#### 第 57/2015 號行政長官公告

## 第 MSC.125 (75) 號決議

**ADOPTION OF AMENDMENTS TO THE GUIDELINES ON THE ENHANCED  
PROGRAMME OF INSPECTIONS DURING SURVEYS OF BULK CARRIERS AND  
OIL TANKERS (RESOLUTION A.744(18), AS AMENDED)**

**AMENDMENTS TO THE GUIDELINES ON THE ENHANCED PROGRAMME OF INSPECTIONS DURING SURVEYS OF BULK CARRIERS AND OIL TANKERS (RESOLUTION A.744(18), AS AMENDED)**

Thickness measurement and typical transverse section indicating longitudinal and transverse members

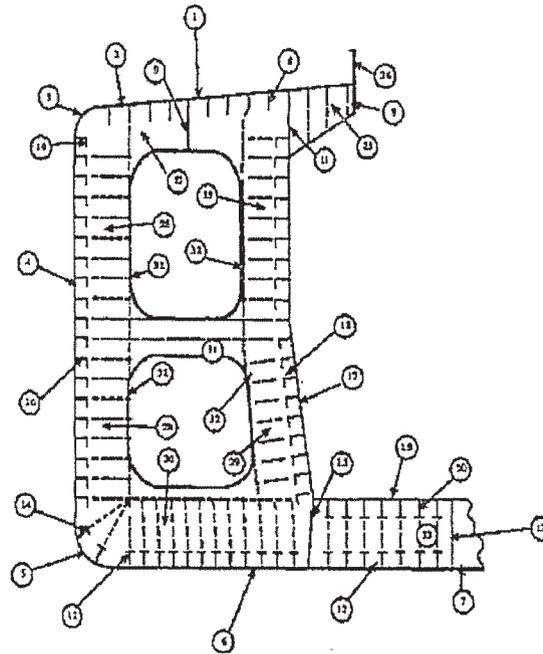
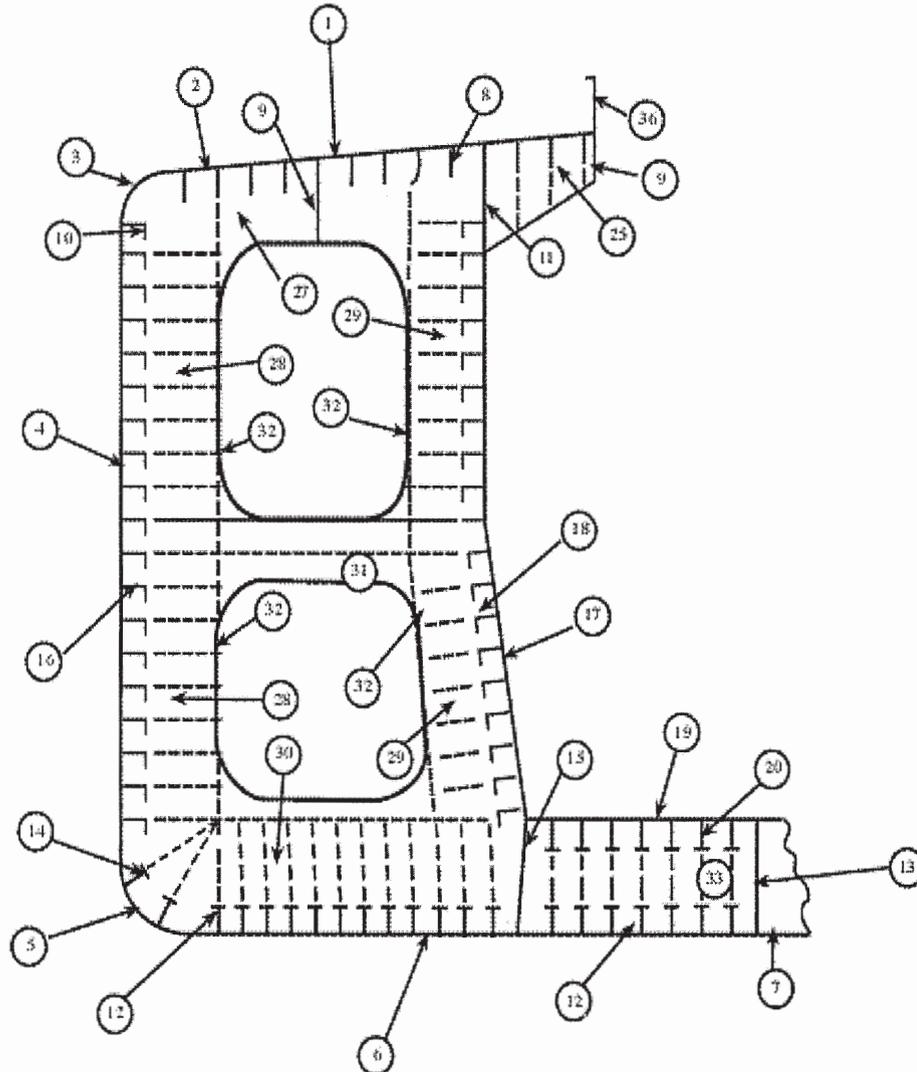
- .2 The following new note is added at the end of the table:
- "3 Any bottom plating with a pitting intensity of 20% or more, with wastage in the substantial corrosion range or having an average depth of pitting of 1/3 or more of actual plate thickness should be noted."
- 13 In annex 8, General, the following new appendices are added to the list of appendices:
- “Appendix 4 Ore carriers – Thickness measurement and typical transverse section indicating longitudinal and transverse members
- Appendix 5 Ore carriers – Thickness measurements and close-up survey requirements”
- 14 In annex 8, the following new appendices 4 and 5 are added after appendix 3:

Report on TM2-BC (1) and (2)	
1.	Strength deck plating
2.	Stringer plate
3.	Sheerstrake
4.	Side shell plating
5.	Bilge plating
6.	Bottom shell plating
7.	Keel plate

Report on TM3-BC	
8.	Deck longitudinals
9.	Deck girders
10.	Sheerstrake longitudinals
11.	Longitudinal bulkhead top strake
12.	Bottom longitudinals
13.	Bottom girders
14.	Bilge longitudinals
15.	Longitudinal bulkhead lower strake
16.	Side shell longitudinals
17.	Longitudinal bulkhead plating (remainder)
18.	Longitudinal bulkhead longitudinals
19.	Inner bottom plating
20.	Inner bottom longitudinals

Report on TM4-BC	
25.	Deck transverse centre tank
26.	Bottom transverse centre tank
27.	Deck transverse wing tank
28.	Side shell vertical web
29.	Longitudinal bulk-head vertical web
30.	Bottom transverse wing tank
31.	Struts
32.	Transverse web face plate
33.	D.b. floors

圖例 1：不帶下底板的船舶

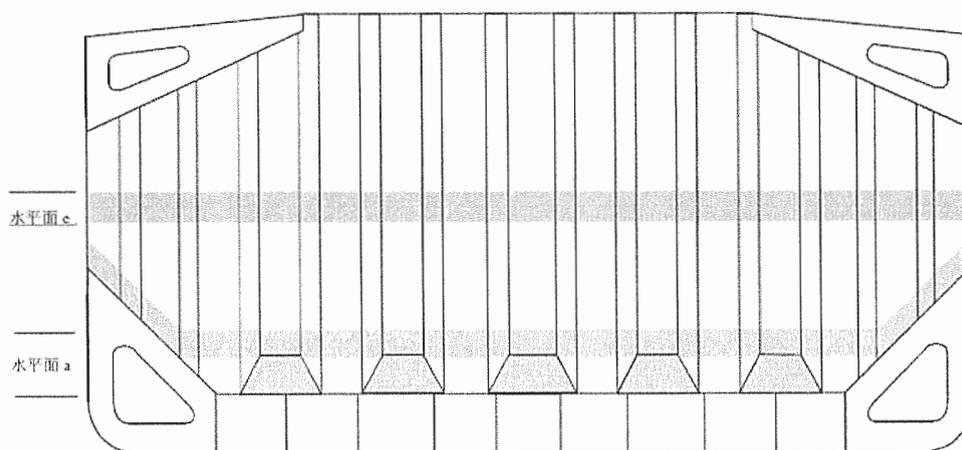
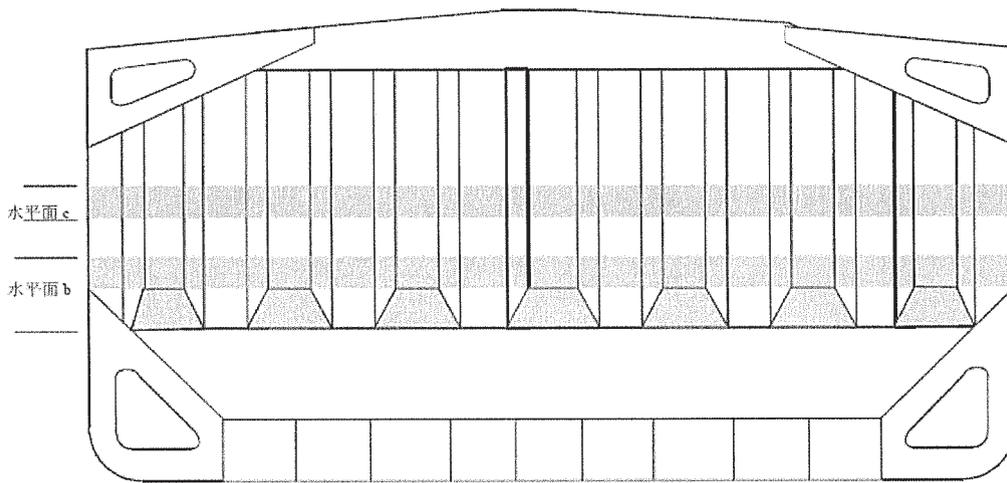
2 考慮到本公約第 XII/1.5 條規定的散貨船艙壁和雙層底強度標準中說明的翹曲模型，決定本附件圖 1 和圖 2 所示的關鍵水平面上的厚度減薄程度是至關重要的。

水平面 (a) 不帶下底板的船舶 (見圖 1)

水平面 (b) 帶下底板的船舶 (見圖 2)

- 卸料板線以上約 200 mm 的波紋凸緣的中間寬度；
- 波紋凸緣之間聯接板（如安裝的話）的中部；
- 卸料板中部；
- 卸料板線以上約 200 mm 的波紋桁材的中間寬度。

- 在波紋的大約中間高度上的波紋凸緣和桁材的中間寬度。

Figure 1. Ships without lower stool

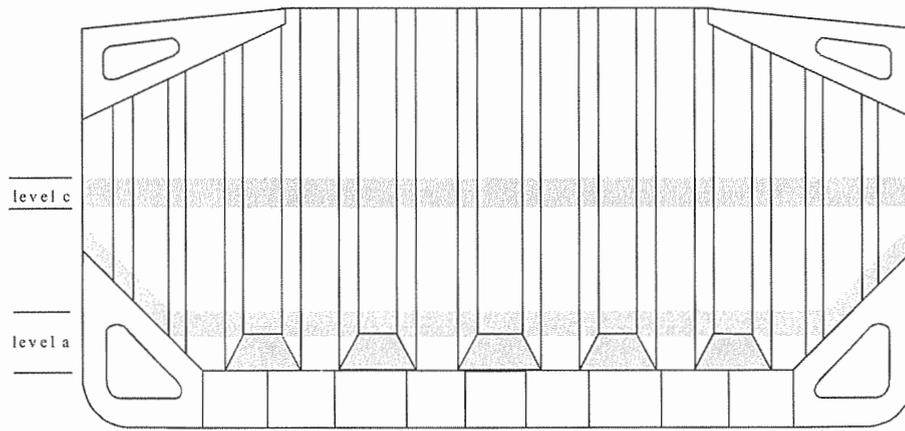
2 Taking into account the buckling model specified in the Bulk carrier bulkhead and double bottom strength standards, defined in regulation XII/1.5 of the Convention, in the evaluation of strength of the bulkhead, it is essential to determine the thickness diminution at the critical levels shown in figures 1 and 2 of this annex.

Level (a) Ships without lower stool (see figure 1):

- The mid-breadth of the corrugation flanges at approximately 200 mm above the line of shedder plates;
- The middle of gusset plates between corrugation flanges, where fitted;
- The middle of the shedder plates;
- The mid-breadth of the corrugation webs at approximately 200 mm above the line of shedder plates.

4 Where the thickness changes within the horizontal levels, the thinner plate should be gauged.

Figure 2. Ships with lower stool

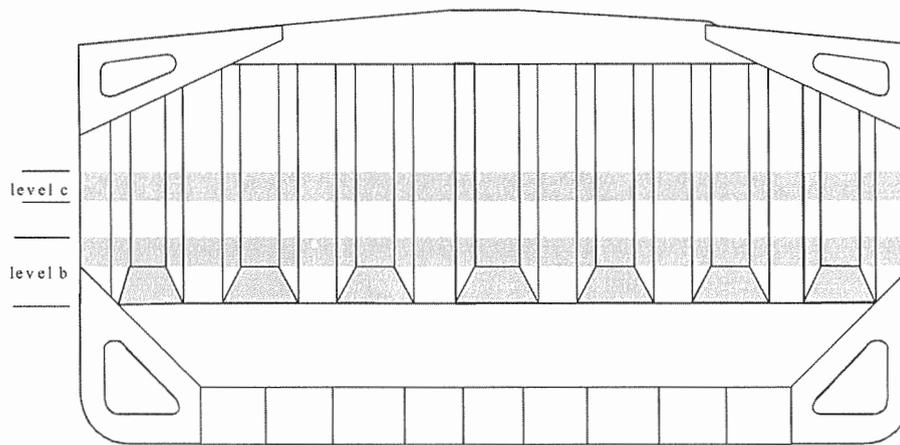
Level (b) Ships with lower stool (see figure 2):

- The mid-breadth of the corrugation flanges at approximately 200 mm above the line of shedder plates;
- The middle of gusset plates between corrugation flanges, where fitted;
- The middle of the shedder plates;
- The mid-breadth of the corrugation webs at approximately 200 mm above the line of shedder plates.

Level (c) Ships with or without lower stool (see figures 1 and 2):

- The mid-breadth of the corrugation flanges and webs at about the mid-height of the corrugation.
